## Assessment of Tinkune-Maitighar Cycle Track Design

Bus Stops (NOW)

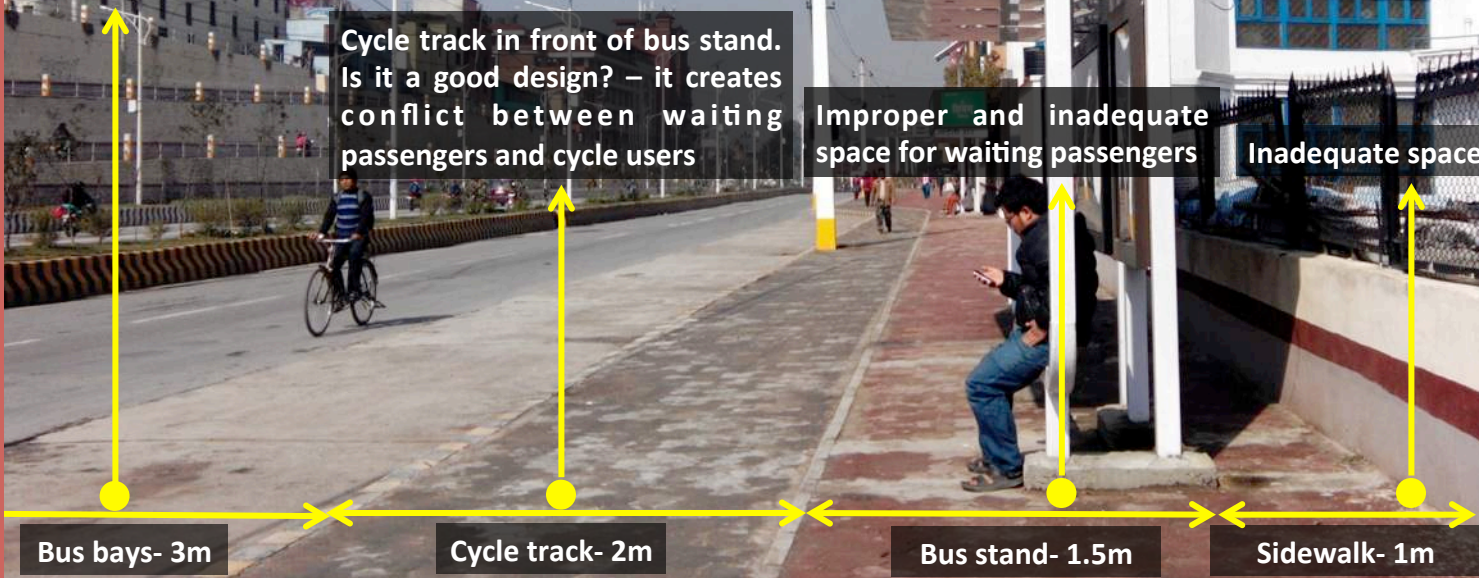
Wider bus bays than required - can be narrowed to create space for waiting passengers

Cycle track in front of bus stand. Is it a good design? – it creates conflict between waiting passengers and cycle users

Improper and inadequate space for waiting passengers

Inadequate space for pedestrians

Intersection (NOW)

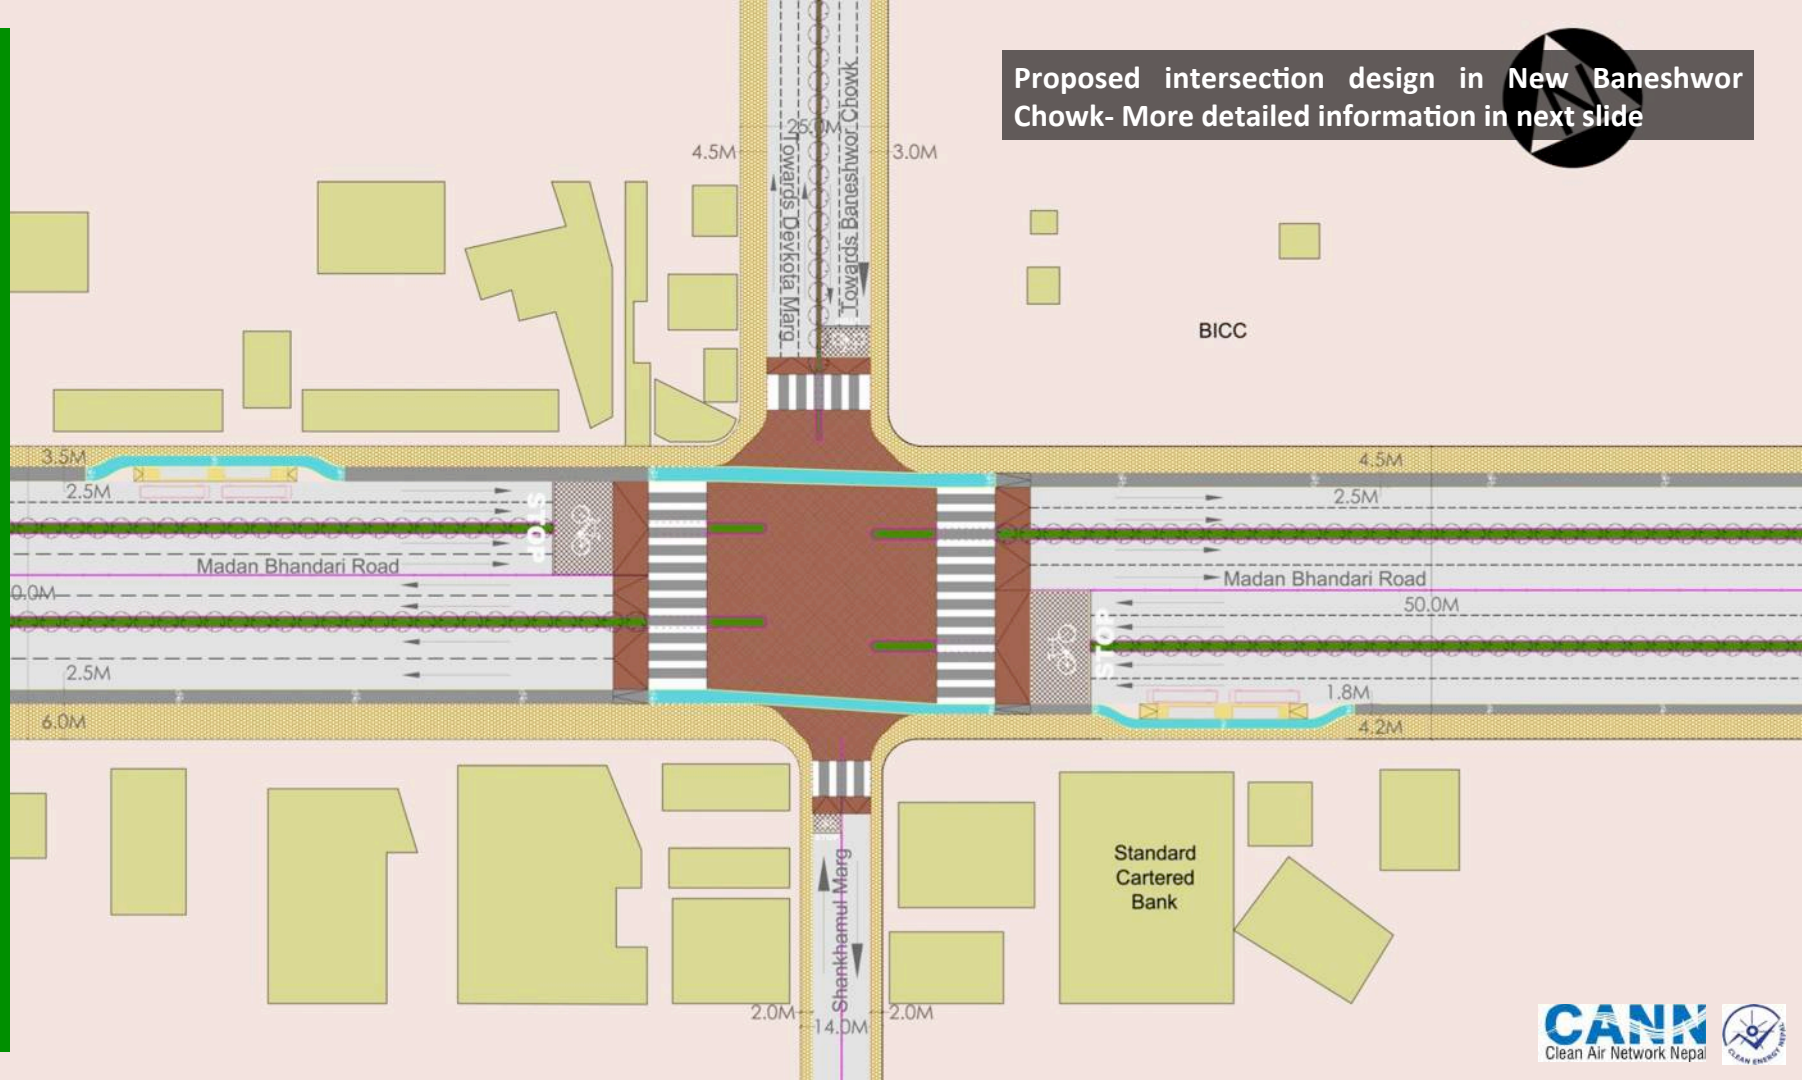
Discontinuous cycle track

No bicycle boxes for queuing at intersection

Faded zebra crossings

No lane markings for cycle users

Lack of pedestrian and bicycle prioritized traffic signals and intersection design

Circular large turning radii - encourage high speed movement of vehicles making it unsafe for pedestrian and cycle users

Obstructions (NOW)

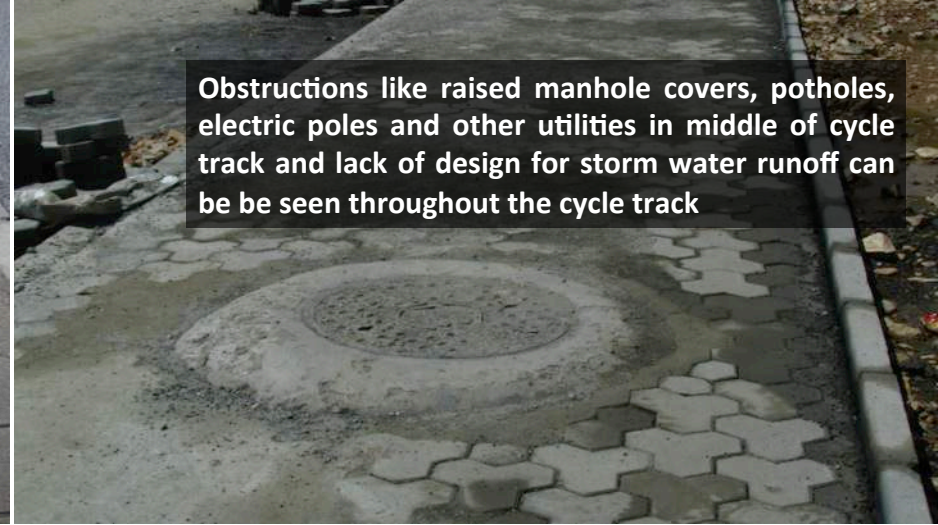
Height - >500mm

Priority is being given to the mobility of vehicles in driveways

Inconsistent and discontinued cycle track and sidewalk can be seen throughout the stretch. This impedes the mobility of users - one of the major design fault, discouraging cycle users to use the track

Obstructions (NOW)

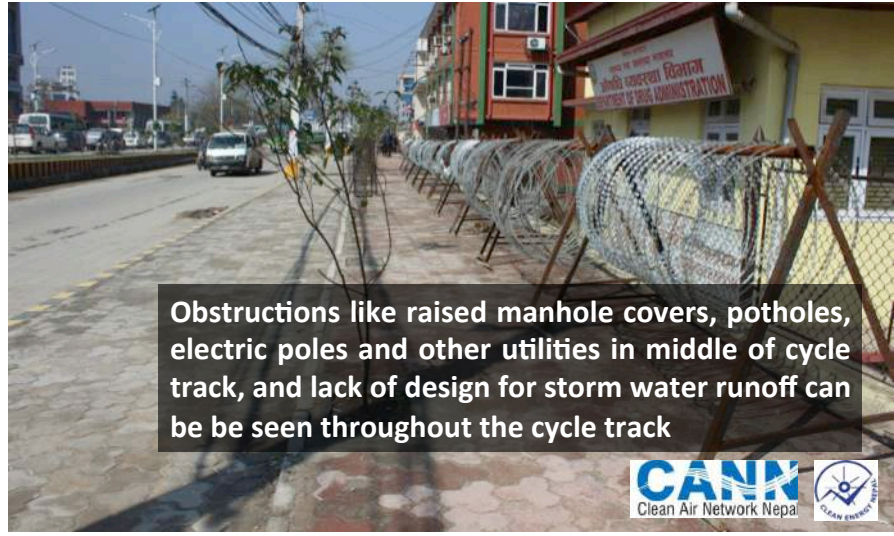
Obstructions like raised manhole covers, potholes, electric poles and other utilities in middle of cycle track and lack of design for storm water runoff can be seen throughout the cycle track
